TECHNICAL MEMORANDUM

Date: October 22, 2015

Subject: Planting Revisions and Substitutions for the Second Year of Construction and Planting (Phase 2) at the Upper Clear Creek Mitigation Site

FIGURE 1 PHASE 2 - 2015 PLANTING ZONE REVISIONS
10.22.15

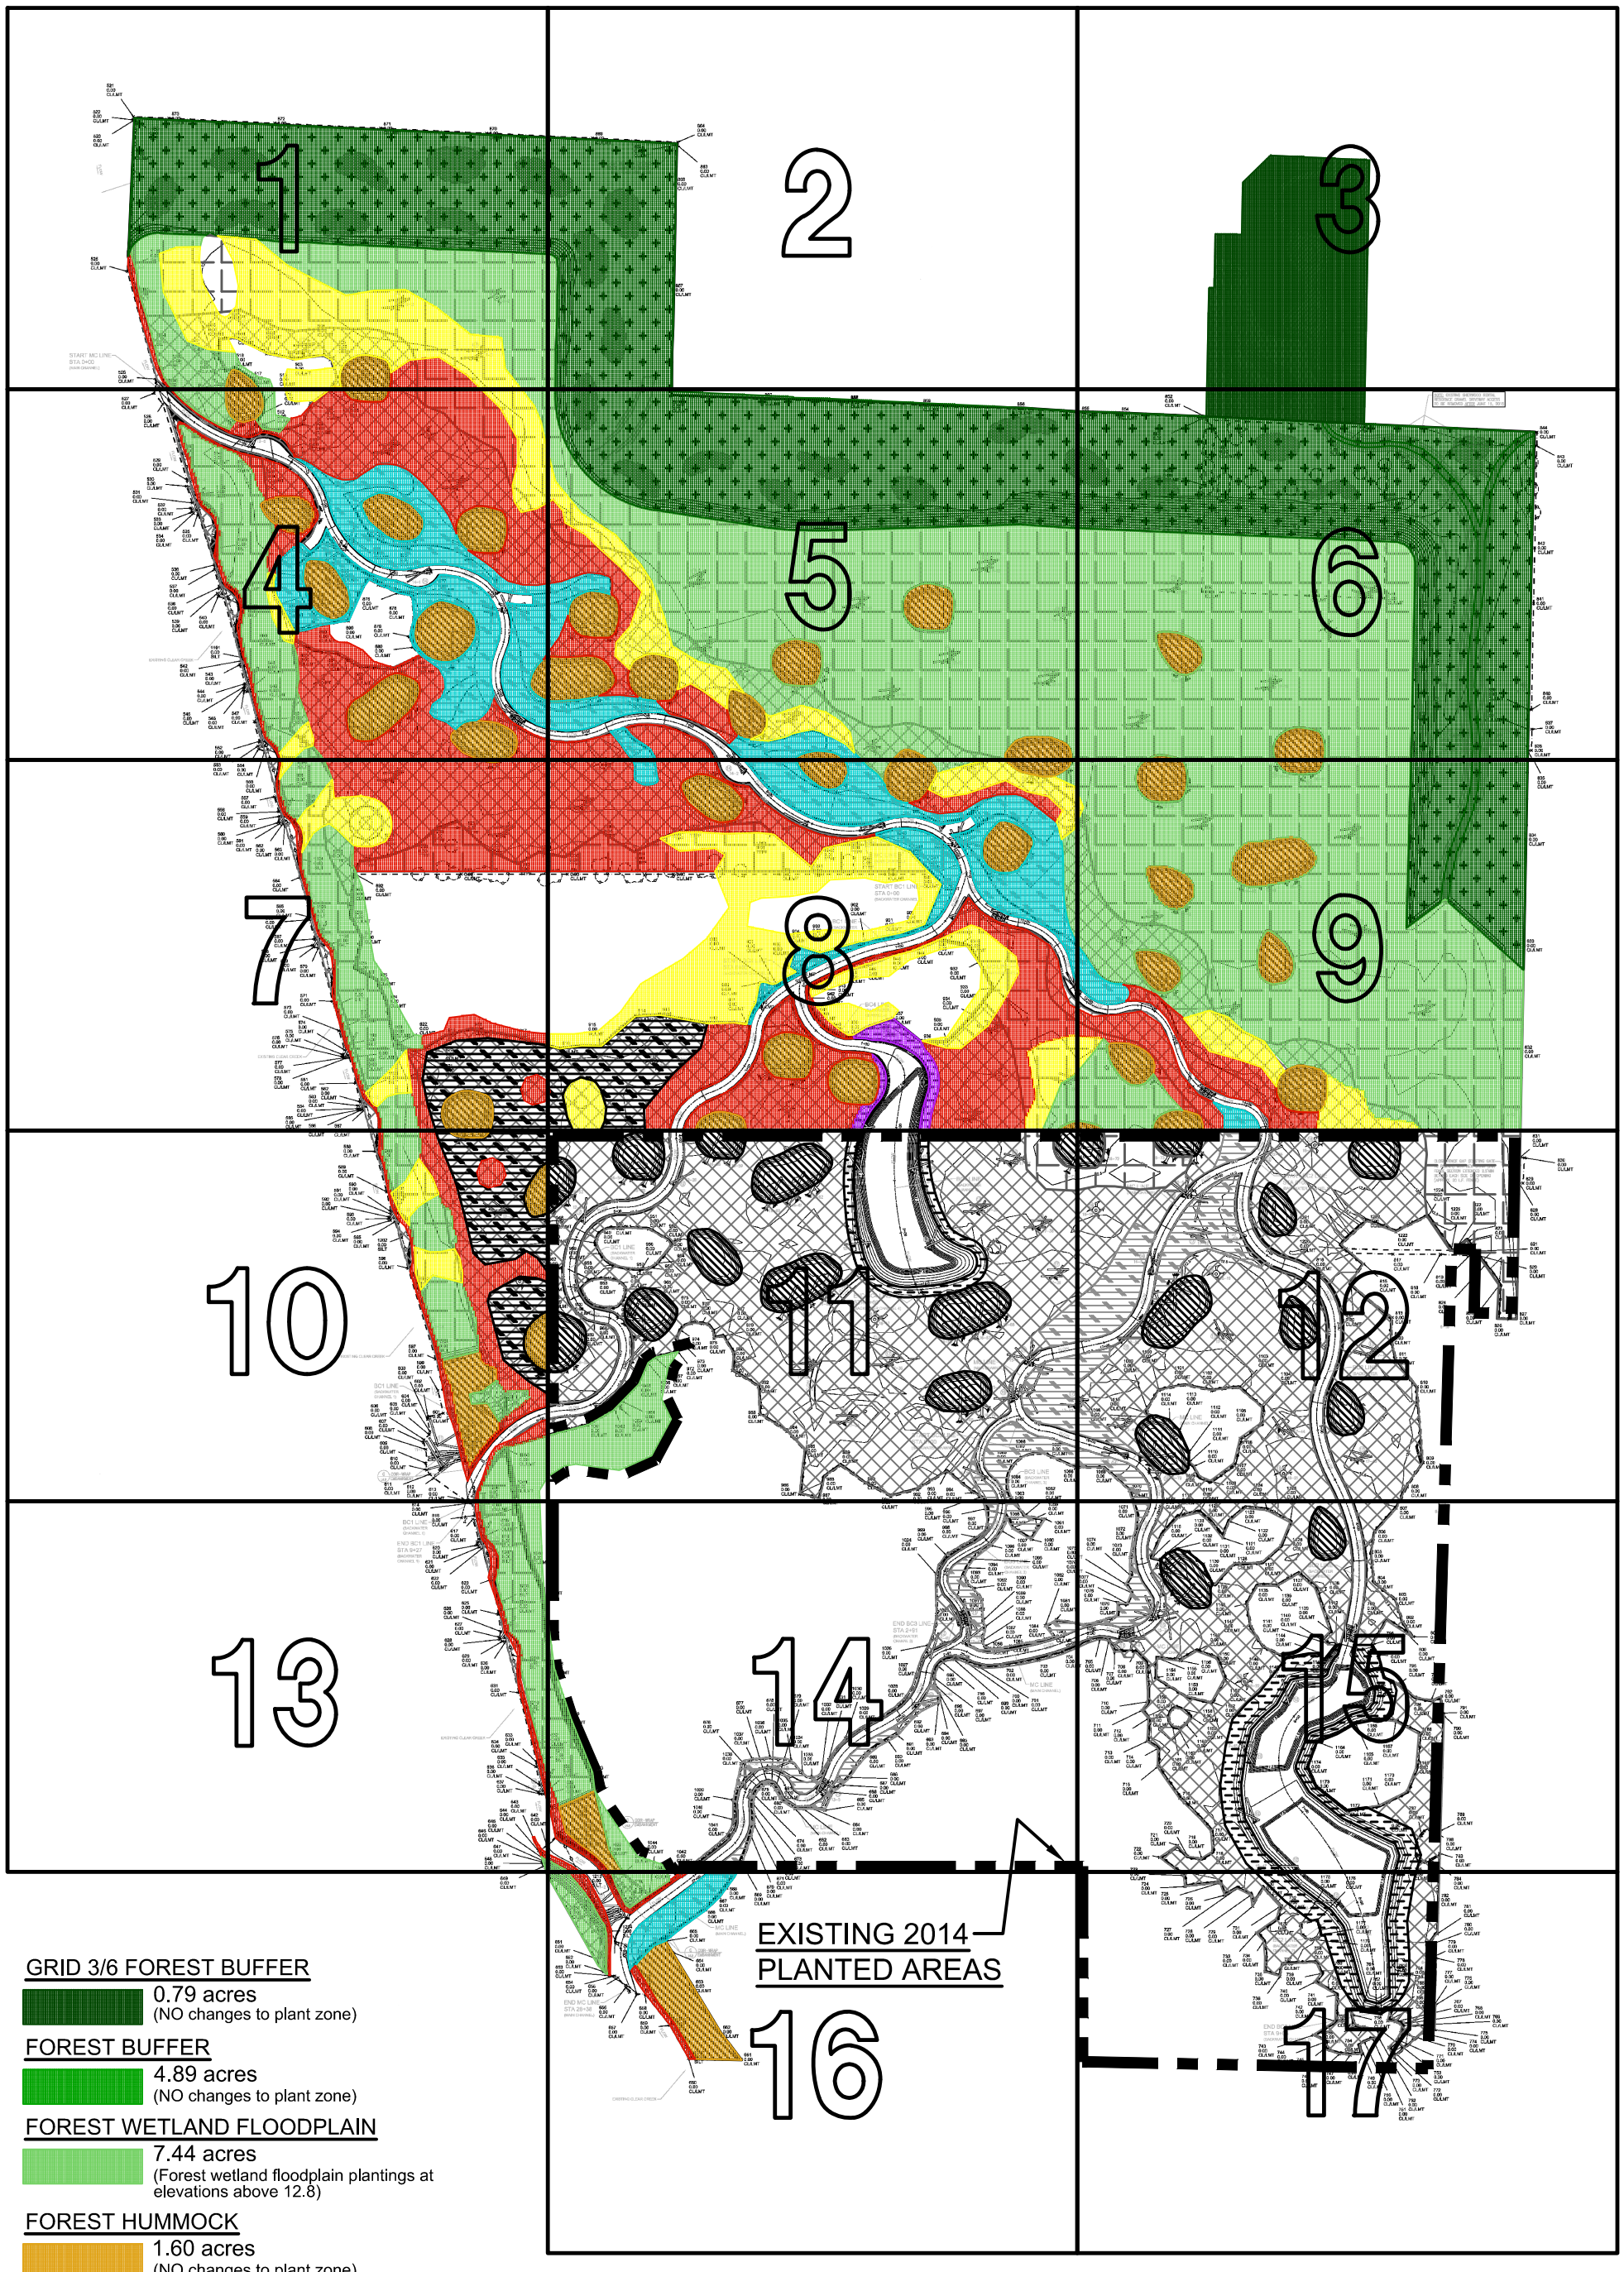
FOREST WETLAND FLOODPLAIN
7.44 acres
(Forest wetland floodplain plantings at elevations above 12.8)

NEW SCRUB-SHRUB WETLAND FLOODPLAIN **(TRANSITION ZONE)**
1.92 acres
(Scrub-shrub wetland floodplain transition plantings (containers) at elevations between 12.8 to 12.5)

NEW SCRUB-SHRUB WETLAND FLOODPLAIN **(FREQUENTLY FLOODED ZONE)**
3.28 acres
(Scrub-shrub wetland floodplain plantings (live stakes) at elevations below 12.5)

NEW EMERGENT WETLAND FLOODPLAIN
0.66 acres
(existing plantings to remain)

In addition to adaptive planting management measures, the Port proposes revisions to the boundaries of retained emergent vegetation, a new emergent wetland floodplain zone, and additional planting associated with expansion of wetland floodplain zones in areas where supplemental reed canarygrass control measures were implemented during construction. These revisions are summarized below and presented in Figure 1.

- During site clearing activities, two areas of existing native emergent vegetation (Grids 1 and 4) that were proposed for retention in the EPA Settlement Area were reduced in size by 0.08 acre to remove additional reed canarygrass around the edges. Scrub-Shrub and Forested Wetland Floodplain plant zones will be expanded into the areas where additional reed canarygrass was removed.

- The Port proposes a new emergent wetland floodplain zone in the Port Umbrella Mitigation Bank Area (Grids 7, 8, and 10). This zone was seeded with the wetland seed mix during the fall of 2014 and was originally planned for planting in Phase 2 as part of a Scrub-Shrub Wetland Floodplain plant zone. Since it was seeded, this zone has established into a dense and diverse emergent plant community colonized by native species from the seed mix and others that established from the existing seed bank (i.e., volunteers). The Port proposes to maintain this new emergent zone with the objective of increasing plant community diversity on the UCCMS. Small patches of Scrub-Shrub Wetland Floodplain zones are proposed within this emergent zone to increase habitat interspersion.

- Forest Wetland Floodplain: Originally specified plant species are proposed and will be evenly distributed. However, to support survival and establishment of plants with less tolerance to inundation, the low ground elevation limit of planting will be adjusted to approximately 12.8 feet, thereby minimizing the potential for sustained temporary inundation associated with the modified upper limit of SBF WSE.

- Scrub-Shrub Wetland Floodplain -- Frequently Flooded Zone: Only live stakes will be installed, consisting of originally specified willow plant species on low-lying areas between 11.5 and 12.5 feet elevation. At these elevations, willow plant species are more tolerant of frequent and longer periods of sustained temporary inundation (i.e., up to two months). Live stakes will be installed at a lengths of 48 inches (four feet) instead of the range of 24 inches to 42 inches specified in the Basis of Design report (BDA et al. 2103). The additional length is intended to prevent submersion which can lead to failed establishment or mortality. The live stakes will be installed in the ground at the originally planned two-foot depth, thereby providing at least one foot above the water surface during times of high SBF WSE. Proposed plant species in this subzone include Pacific willow (*Salix lasiandra*), Geyer's willow (*S. geyeriana*), Hooker willow (*S. hookeriana*), and Sitka willow (*S. sitchensis*).

- Scrub-Shrub Wetland Floodplain -- Transition Zone: Only originally specified container-grown plant materials will be installed on relatively higher ground between 12.5 and 12.8 feet elevation. At these elevations, these originally specified plant species are more suited for shorter periods of sustained temporary inundation (i.e., less than one month). Proposed plant species include red twig dogwood (*Cornus sericea*), black twinberry (*Lonicera involucrata*), crabapple (*Malus fusca*), Pacific ninebark (*Physocarpus capitatus*), and peafruit rose (*Rosa pisocarpa*).

Figure 2.
Phase 2 Plant Zones and Sustained Base Flow Water Surface Elevation (WSE).

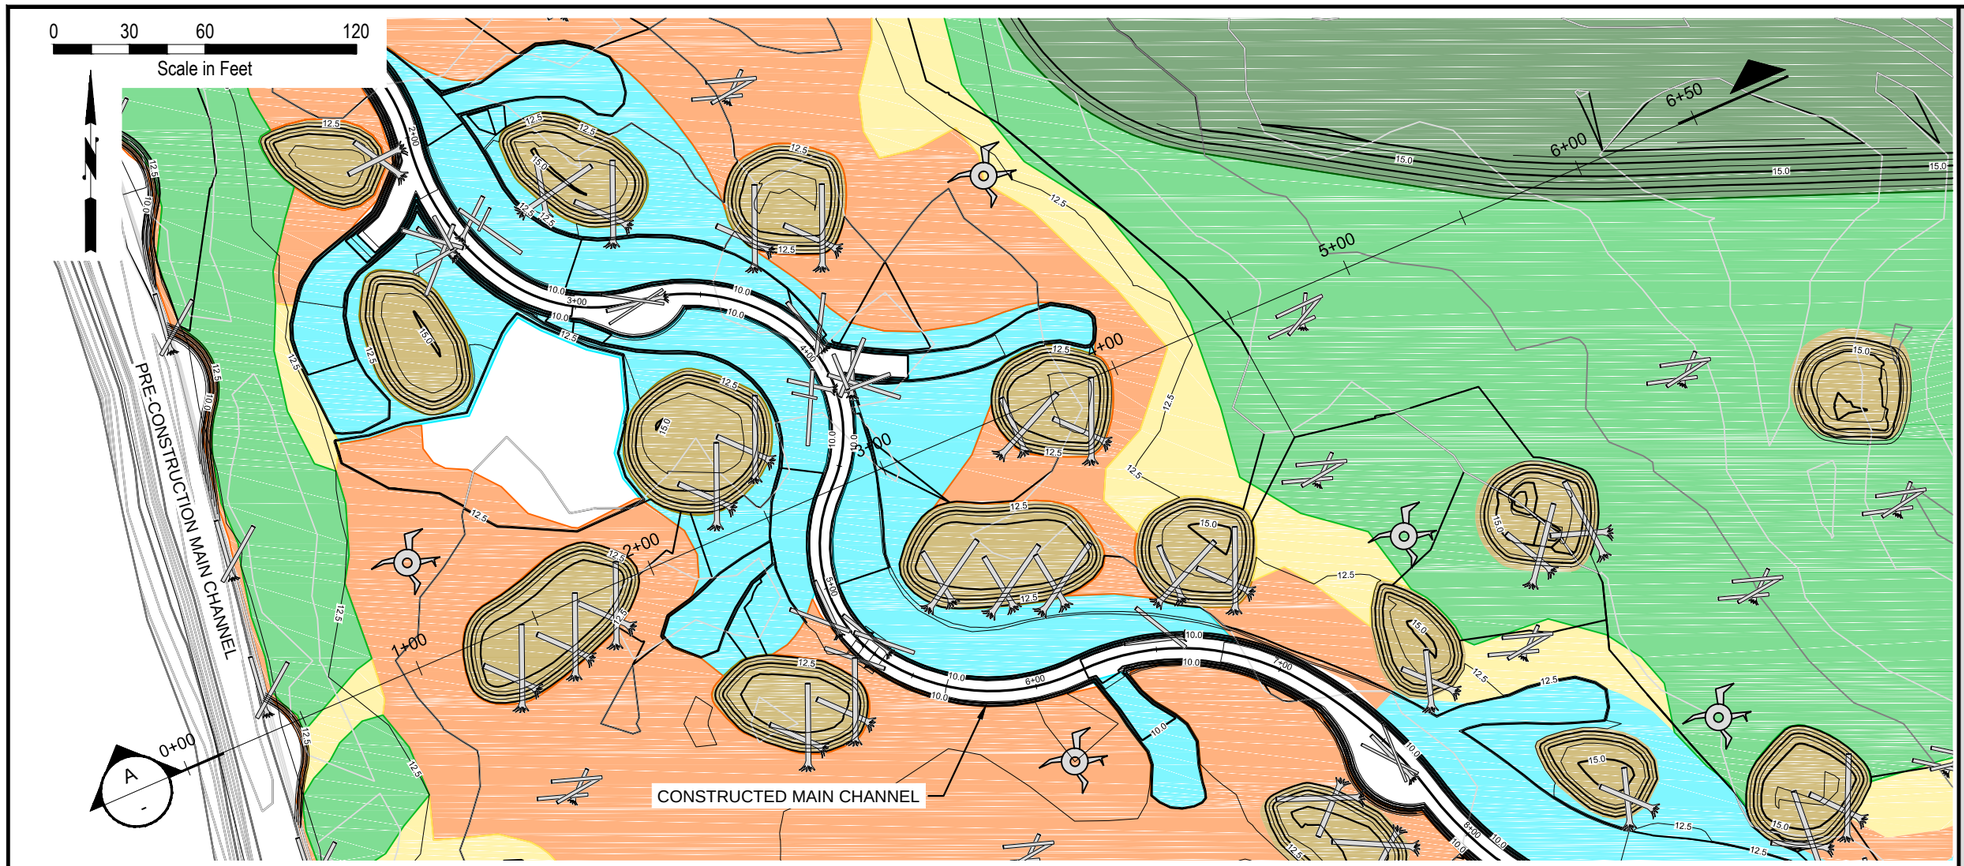
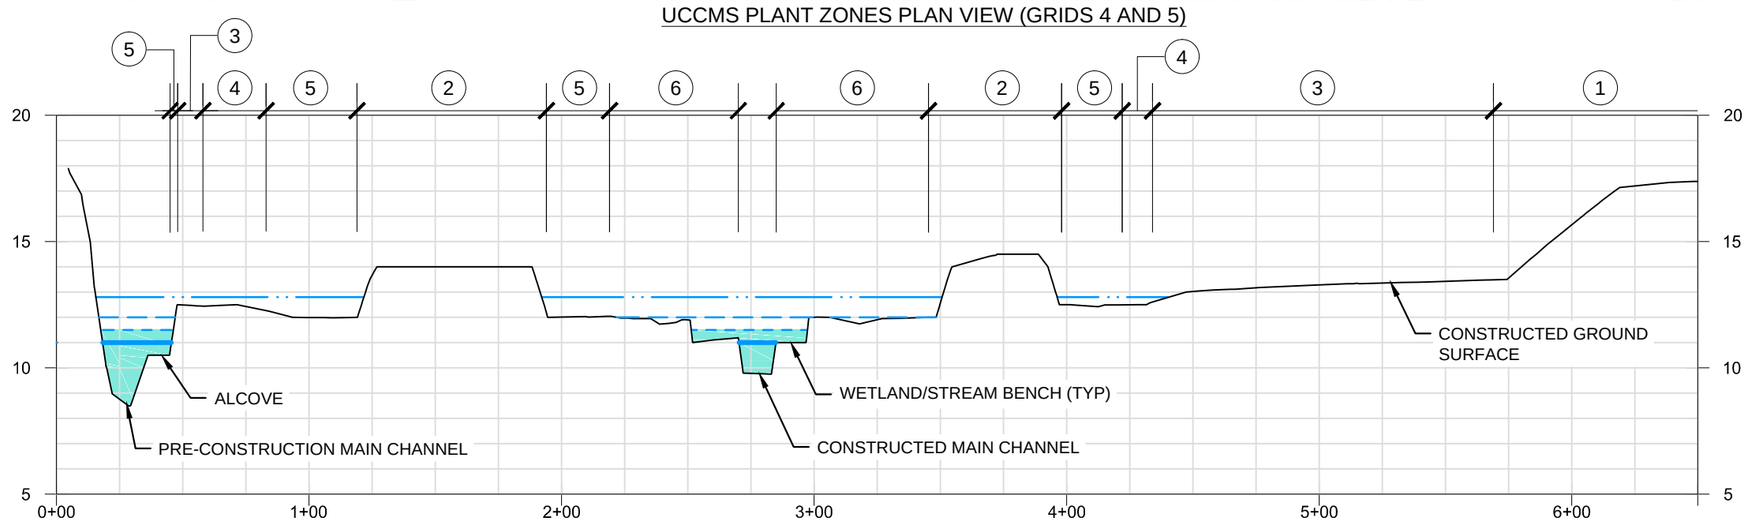
Plant zone adjustments for Phase 2 are summarized below. Figure 1 presents the revised boundaries and locations of Phase 2 plant zones and Table 1 presents the corresponding plant schedule. Figure 2 presents adjusted Phase 2 plant zones in relation to SBF WSEs. Within all of the revised plant zones, plants will be spaced according to originally proposed on-center spacing (12 feet for trees; 5 feet for shrubs; 1.5 or 2.5 feet for groundcover; and 1.5 feet for emergent). As originally proposed, where live stakes are planned, they will be installed as pairs at each on-center planting location.

- Scrub-Shrub Wetland Floodplain: Two distinct plant subzones within the Scrub-Shrub Wetland Floodplain zone will be designated at different ground elevation ranges corresponding to potential SBF WSE. Originally specified plant species are proposed, but they will be redistributed to each subzone based on relative inundation tolerance.
